A. Statement of Technical Rationale and Justification

This Off-cycle Emissions (OCE) gtr includes two components. First, it contains provisions that prohibit the use of defeat strategies. Second, it introduces a methodology for limiting off-cycle emissions. This OCE gtr adopts the World-Harmonized Not-to-Exceed requirements(WNTE) methodology. The WNTE includes harmonized off-cycle emissions factors applicable under a broad range of engine and ambient operating conditions. In the future, other methodologies for limiting off-cycle emissions may be introduced.

Figure 1 : Illustration of Ambient Altitude and Temperature Conditions

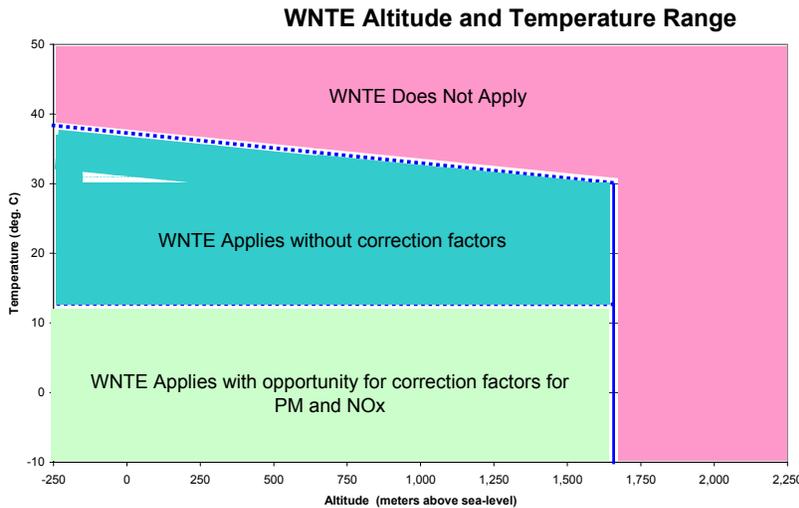
EC Comment: Is chart necessary? – if so needs to be updated so that no correction factors included

Figure 2: Example Not-To-Exceed Control Area When C Speed < 2,400 rpm

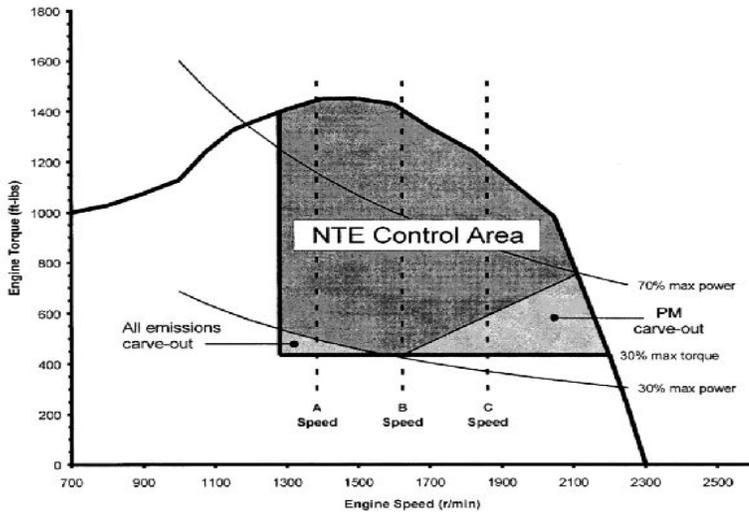
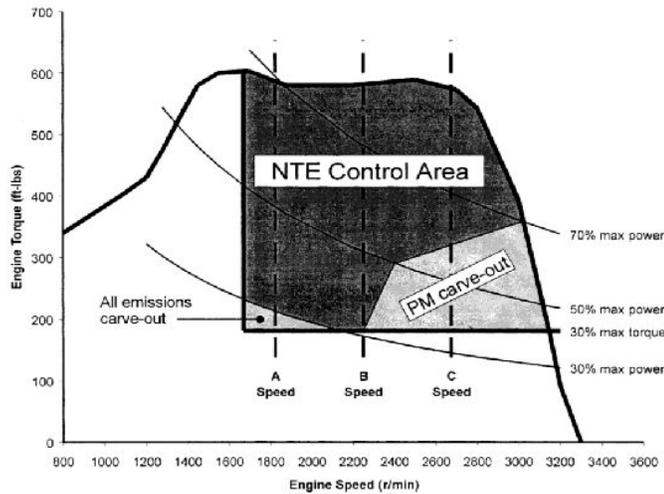
EC Comment: We consider that this text is unnecessary for a GTR and should be removed

Editorial Comment: Will update diagrams to correspond with final control area established in gtr and will add example figures without PM carve out.
